ANSI-ASC-C63[®] Interpretation Request Form

Submission Date	Originator Name, Company
12/17/2015	Yujiro Seki, IPS Corporation

Standard	Clause/ Sub clause	Paragraph Figure/ Table	Type (General/ Technical/ Editorial)	Comment / Inquiry	Subcommittee Response <i>(to be filled in by Subcommittee Chair)</i>
ANSI C63.4-2014	5.5.1	a) 1), 2) i), b)	Technical	<p>The wording in ANSI C63.4-2014, clause 5.5.1, limits the height of the absorber material to 30 cm, whereas CISPR 16-1-4:2010+A2:2012 specifies the height of the illumination area that may be obstructed by absorber.</p> <p>ANSI C63.4-2014 5.5.1 a) 1), 2) i), b) “The RF absorbing material used on the reference ground plane.... shall have a maximum height (thickness) of 30 cm”</p> <p>CISPR16-1-4:2010+A2:2012, clause 8.3.1: “... illumination of the test volume for a height of up to 30 cm may be obstructed by absorber placed on the ground plane.”</p> <p>Please refer to the CISPR figure attached.</p>	<p>It is correct that C63.4 does not allow absorber nominal height to exceed 30 cm to place some limit on the height of the absorber. For validation of the interpretation of a given requirement in CISPR 16-1-4, contact the responsible committe

Figure 21 – S_{VSWR} Positions (height requirements)

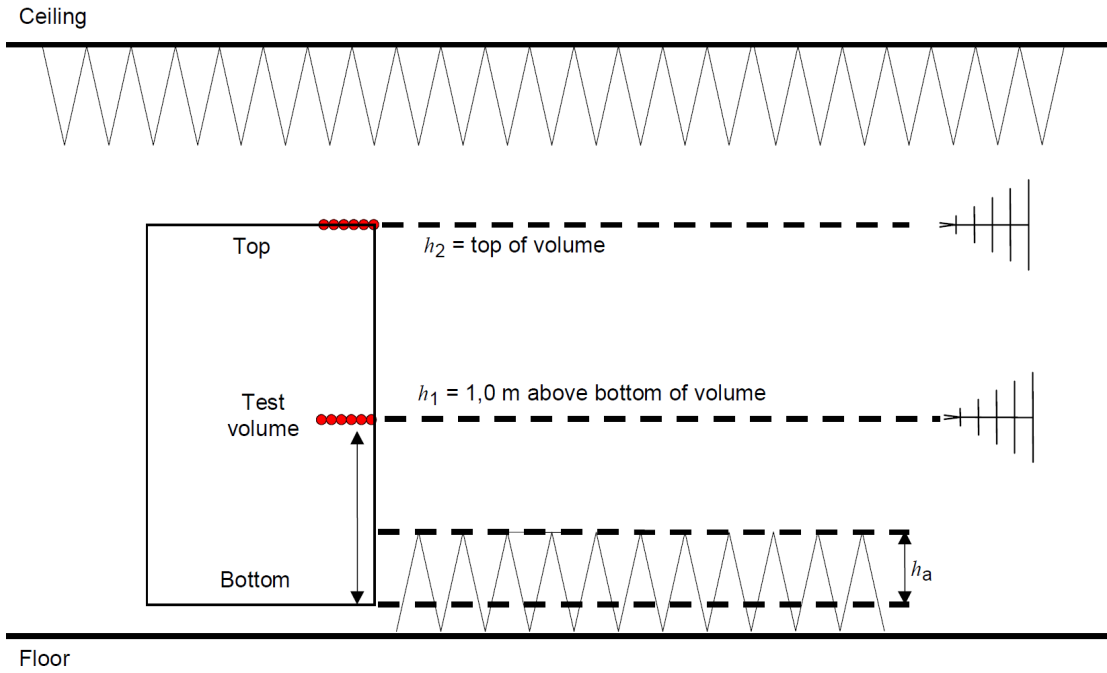
Standard	Clause/ Sub clause	Paragraph Figure/ Table	Type (General/ Technical/ Editorial)	Comment / Inquiry	Subcommittee Response <i>(to be filled in by Subcommittee Chair)</i>
				<p>The bottom of the test volume is raised from the floor and the test volume may be obstructed by the absorber material up to 30cm from its bottom.</p> <p>CISPR16-1-4:2010+A2:2012, Figure 21 – S_{VSWR} Positions (height requirements) Key: “h_a: the portion of the test volume that is obstructed by absorber placed on the floor (30cm maximum)”</p> <p>This means a lab may use absorbers exceeding 30 cm as per CISPR, but it may not when it applies ANSI.</p> <p>We would like to know if the fundamental idea for both standards is the same, and if positive, we would like to suggest that the wording be changed in order to specify a 30 cm obstruction area instead of simply limiting the absorber height.</p> <p>This will allow test sites that only test tabletop equipment to have more options such as to raise test volume and use taller absorbers. This may also contribute to improve S_{VSWR} characteristics and evade economic burden for those labs that only possess >30 cm absorbers.</p>
